11 HIGH STREET
YAMBA 2464

**SECTION 4.15 EVALUATION FOR DA2021/0374
- Lot 91 DP 1154781- 11 High Street YAMBA NSW 2464**

Proposal: Alterations and additions to an existing single storey dwelling to created a second storey, adding a master bedroom and ensuite.

DRAWING
SHADOW DIAGRAMS

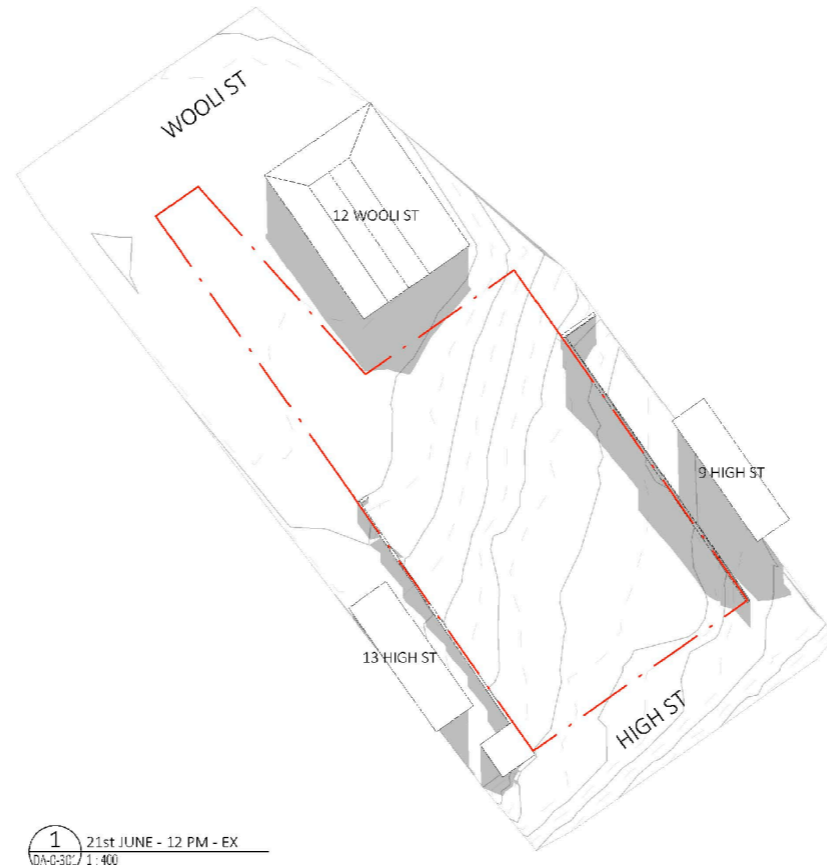
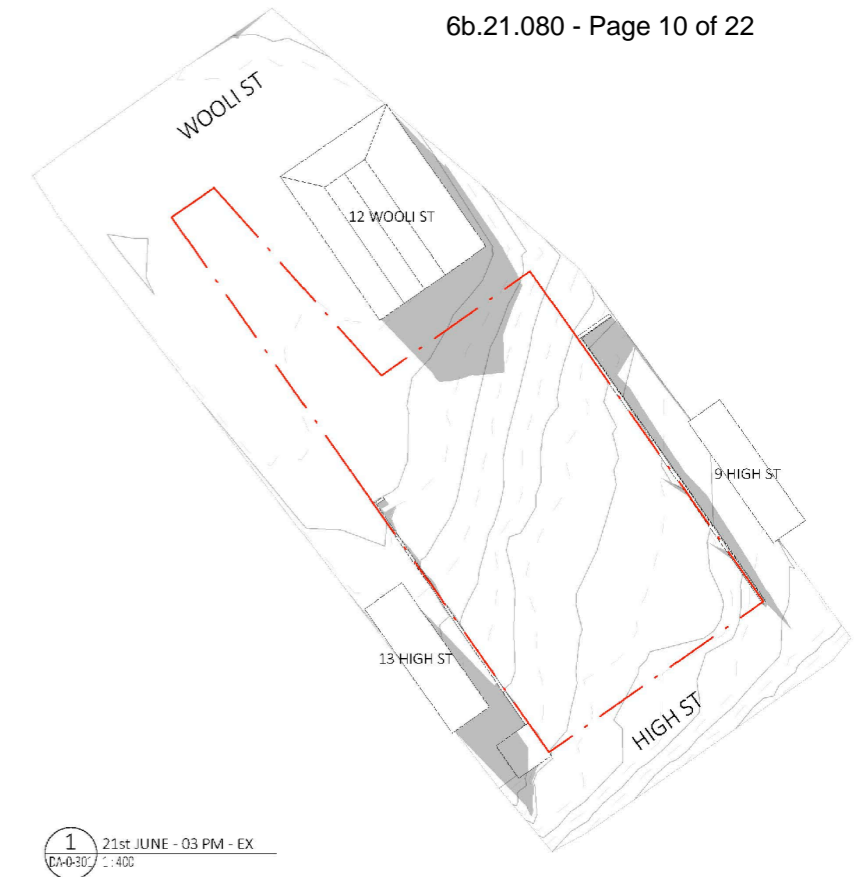
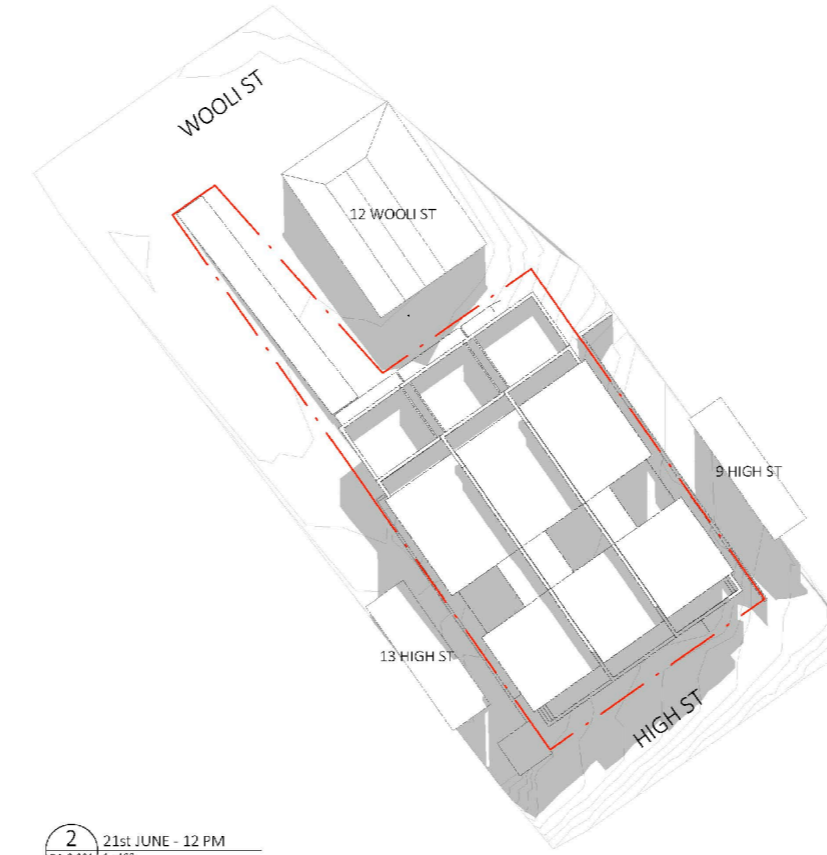
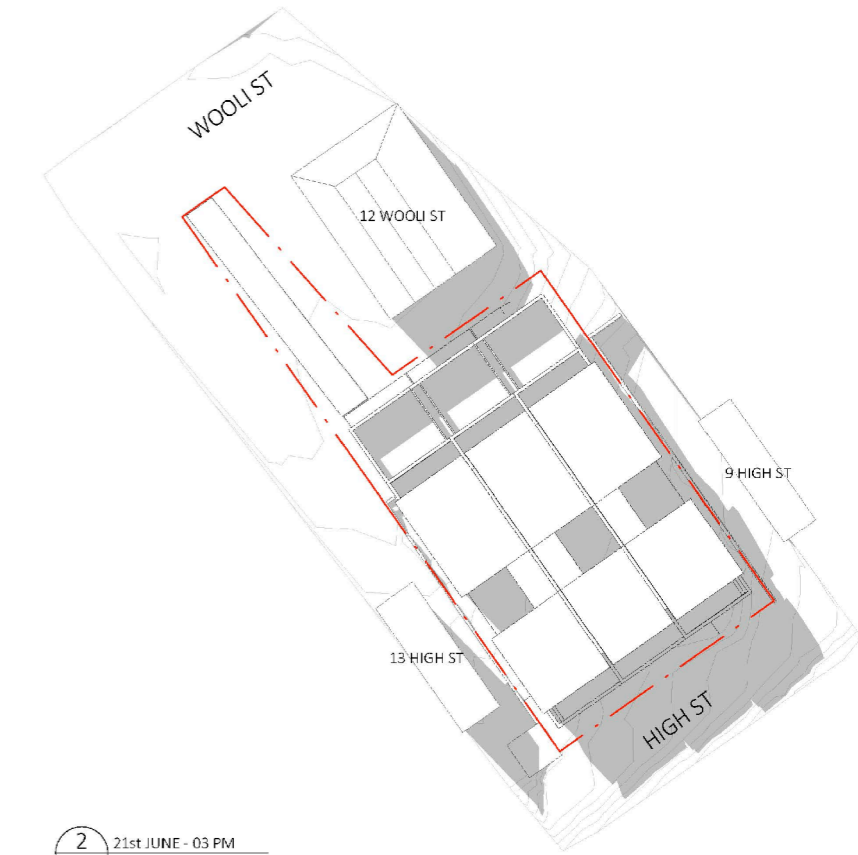
Section P7 of the DCP (Yamba Hill Controls) provides that 'at least half the private open space of adjoining properties should receive direct sunlight between 10am and 2pm during mid winter'. The shadow diagrams provided with the proposal show that only part shadowing occurs on 13 High Street in the morning and is reduced throughout the day during mid winter.

Section P7 of the DCP (Yamba Hill Controls) provides that 'at least half the private open space of adjoining properties should receive direct sunlight between 10am and 2pm during mid winter'. The shadow diagrams provided with the proposal show that only part shadowing occurs on 13 High Street in the morning and is reduced throughout the day during mid winter.

The shadow diagrams adequately show the shadowing impacts created by the building and the location of the sun. No overshadowing of 12 Wooli Street will occur from the buildings. View lines through the property are not considered to create an adverse impact given there are single storey dwellings on either side of the lot and the adjoining buildings on the southern side of High Street are upslope and essentially overlook the proposed buildings.

Use of grass-crete surface and inclusion in the landscape calculation

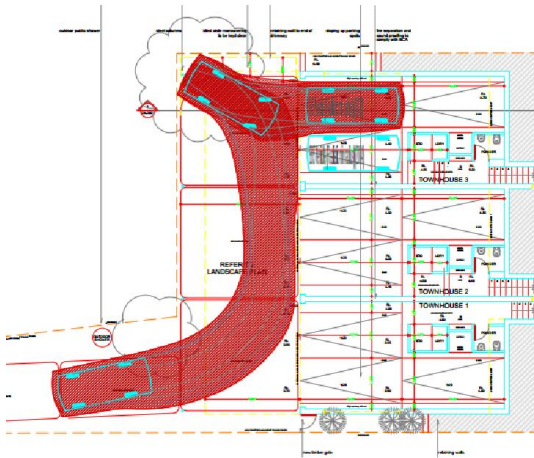
Council staff advised the Applicant that where grass-crete is used it should only account as 50% of area in the landscaped area calculation.

The Applicant re-calculated the landscaped area and submits that the development provides 240m² (33%) of landscaped area to the required 35% under the DCP.

The minor reduction is considered acceptable under the circumstances given the battleaxe driveway has a considerable slope and the grass-crete provides a better visual outcome to a hardstand driveway and will be a semi-permeable surface to allow for adequate drainage along the driveway. The north and eastern aspect of the driveway will also allow for the grass to grow in this location.

Figure 5: Manoeuvring diagram parking space for townhouse 3

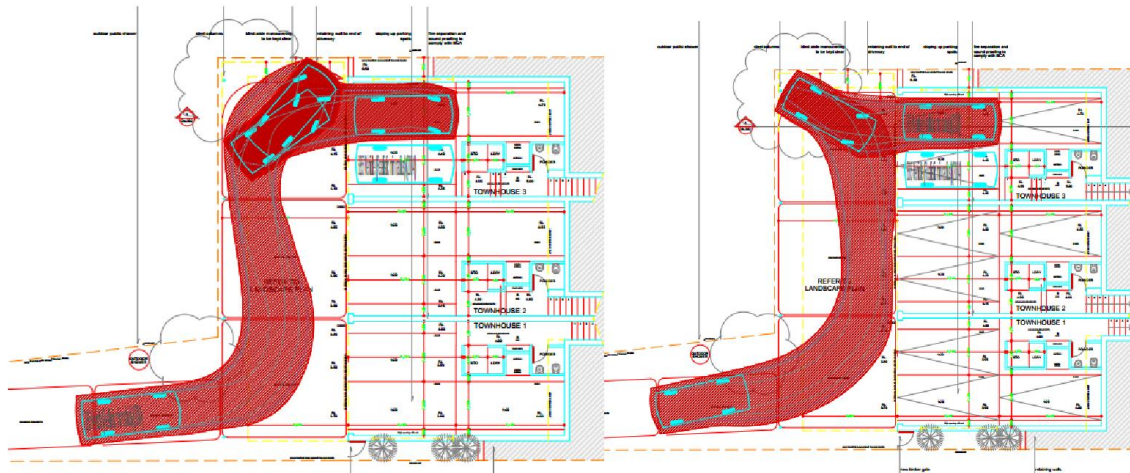
Three (3) parking spaces for each unit are required under the Yamba Hill DCP controls and stacked parking is proposed for one of the parking spaces for each unit. Part G – 'Parking and Vehicular Access' controls provides that stacked parking will not be accepted (Subclause G2(9)).

Discussions with the architect for the development indicated that the current design was required to eliminate the need for a very large basement area with manoeuvring areas, required excavation and increased height of the buildings.

The variation to the parking design for one of the parking spaces per unit, is considered to be a design outcome that is not ideal though is a preferred option to the alternatives of considering a reduction in the number of spaces overall and excavation required to provide a compliant car parking area. The location of the site will likely mean that tenants will be able to walk to the Yamba CBD. The manoeuvring diagrams provided in **Figure 5** have demonstrated that the spaces can be suitably accessed and allow for a vehicle to leave in a forward direction. For these reasons the proposal is considered acceptable in the circumstances.

Figure 6: Proposed landscape areas and private open space

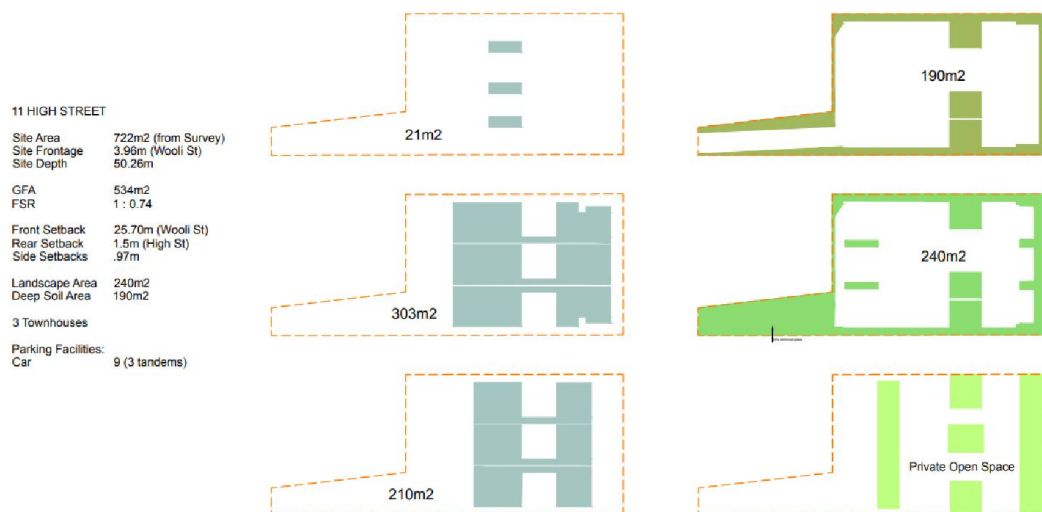
Figure 6 below shows the area calculation for landscaped area and private open space. The DCP describes landscaped area 'as a part of the site used for growing plants, grasses and trees but does not include any building, structure or hard paved area'. In addition to areas with good sunlight exposure other areas that are subject to reduced or shaded light can be planted with shade tolerant plants. The reduction to the landscaped area has been discussed above.
